Office Action Summary	Application No. 10/600,206	Applicant(s) SEGOTA ET AL.	
	Examiner Benjamin P. Lee	Art Unit 3641

DETAILED ACTION

Wells, et al.

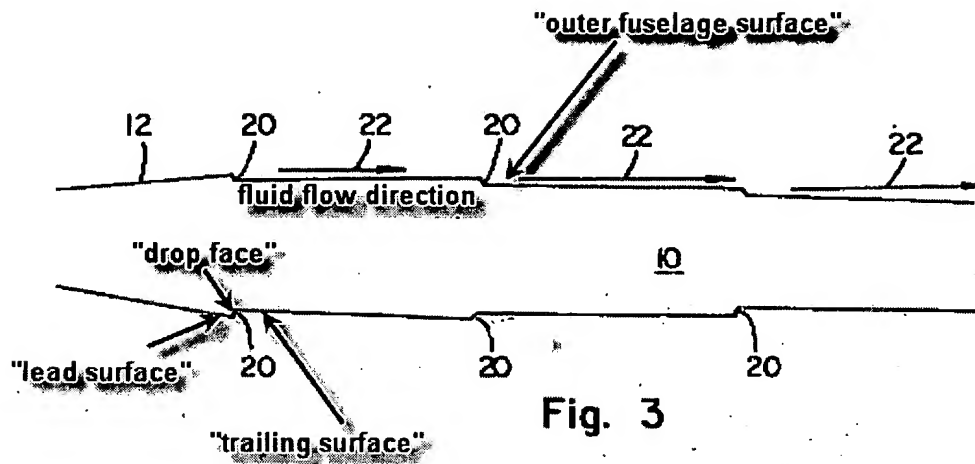
8. In regards to claims 1 and 18, Wells et al disclose a fuselage comprising the following:

- b. an outer fuselage surface relating with said frontal fuselage portion that receives fluid flow thereon (see Wells et al fig. 3 following);
- c. at least one fluid flow regulator featured and operable with said outer fuselage surface and extending at least a partial distance around said fuselage (items 20 of Wells et al fig. 3 following and col. 4, lines 63-67);

- d. fluid flow regulator comprising a leading surface and a trailing surface (see Wells et al fig. 3 following);
- e. a pressure recovery drop extending a pre-determined distance between said leading and trailing edges to form a down step, said pressure recovery drop comprising at least one drop face of a calculated distance (col. 3, lines 30-35), said fluid flow regulator functioning to regulate existing pressure gradients along said fuselage to optimize and equalize said fluid flow and to reduce the separation potential of said fluid, wherein said regulation of said pressure gradients positively influences the flow properties and behavior of said fluid across said fuselage, and thus the performance of the craft comprising said fuselage (see Wells et al fig. 3 and col. 3, lines 30-54);

- g. a trailing edge that defines and extends from the base of said pressure recovery drop that provides a trailing flow boundary for said fluid (see Wells et al fig. 3 following). Note that the "trailing surface" extends from the "pressure recovery drop" and inherently provides a trailing flow "boundary" for the fluid.

10. In regards to claim 3, Wells et al disclose that the pressure recovery drop is oriented substantially perpendicular to the direction of flow of said fluid (see Wells et al fig. 3 following).

11. In regards to claim 4, Wells et al disclose that the pressure recovery drop comprises a linear formation (see Wells et al fig. 3 following).

14. In regards to claim 8, Wells et al disclose that the outer fuselage surface features a plurality of fluid flow regulators that function together to regulate, influence, and control fluid flow and its properties and characteristics across said outer fuselage surface (see Wells et al fig. 3 following and col. 3, lines 39-45 and 55-59).

16. In regards to claim 13, Wells et al disclose that the fluid flow regulator is integrally formed with said outer fuselage surface (see Wells et al fig. 3 following).

17. In regards to claim 15, Wells et al disclose that the pressure recovery drop comprises a plurality of drop faces to magnify the influence of fluid flow regulator on said fluid (see Wells et al fig. 3 following).

FIG. 3

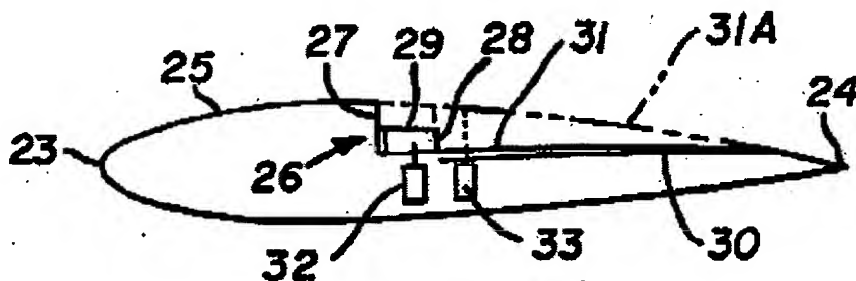
22. In regards to claims 17 and 25, Wells et al fail to explicitly disclose that the pressure recovery drop comprises an orthogonal design. However, Smith et al disclose a "drop" that is at a right angle to the fluid flow surface (see Smith et al fig. 3 following). It would have been obvious to one of ordinary skill in the art at the time of applicant's invention to require that the "drop" is at a right angle to the flow surface as disclosed by Smith et al to achieve the most significant pressure drop.
